SHOREHAM NUCLEAR POWER STATION

SNRC-585

HUMAN FACTORS ENGINEERING
CONTROL ROOM DESIGN REVIEW

LILCO RESPONSE TO NRC AUDIT FINDINGS
SHOREHAM NUCLEAR POWER STATION - UNIT 1

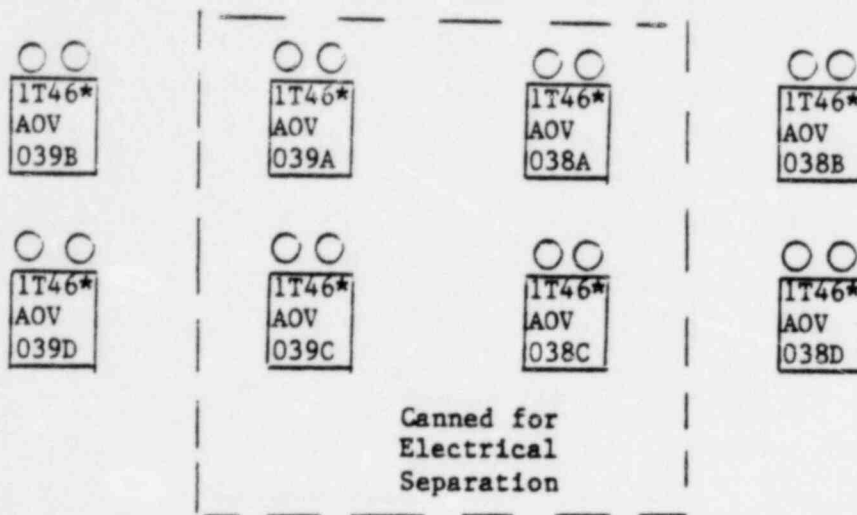
The annunciators for NSSS A/B Isolation and NSSS C/D Isolation read logically from left to right although they are on different annunciator panels. The associated Manual Isolation control buttons are arranged in left to right sequence CDAB. (2)

The annunciators and/or switches will be relocated to have the same sequence on both. This will be accomplished by fuel load.

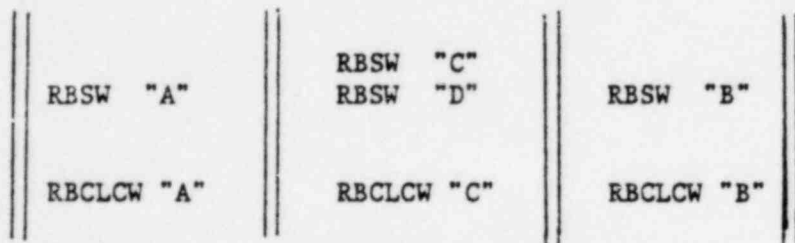
Reactor Building Closed Loop Cooling Water Pump ABC and Service Water Pump ABCD control sequences are not in standard sequential order. (2)

Shoreham is a two train plant, but because of safety system power requirements three safety buses with diesel back-up were provided. Therefore, the Division III (orange) train is not a complete separate entity. It is integrated with Division I and II for ease of operation and separation. Board layout for the three trains is Div. I, Div. III, and Div. II. See below:

Reactor Building Service Water Pumps A and C are in the same mechanical flow loop, and pumps B and D are in the other mechanical flow loop. RBCLCW Pump "C" can be mechanically lined-up with either the A or B pumps. LILCO will demarcate to show division I, II and III separation prior to fuel load.

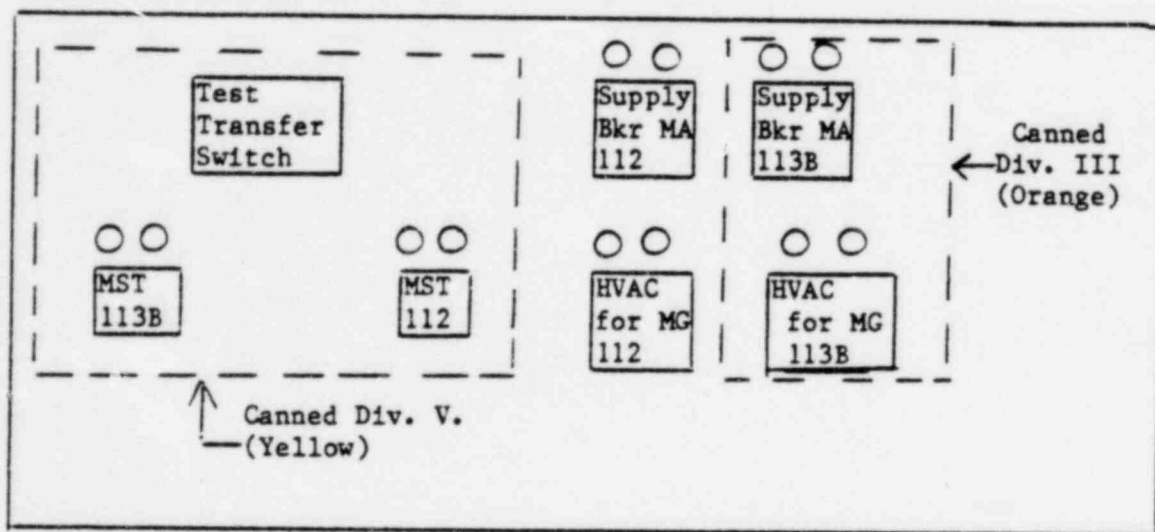
Transfer switch MST 113B and related switch MG 113B are separated by switch 112 and a breaker. Similar arrangements are found for switch 111 and switches 113A. (2)

LILCO will review switches MST 112 and 113B and provide color pad enhancement for the entire switch cluster diagramed above. A similar change will be accomplished for Division I switches on panel 601. This will be accomplished prior to fuel load.
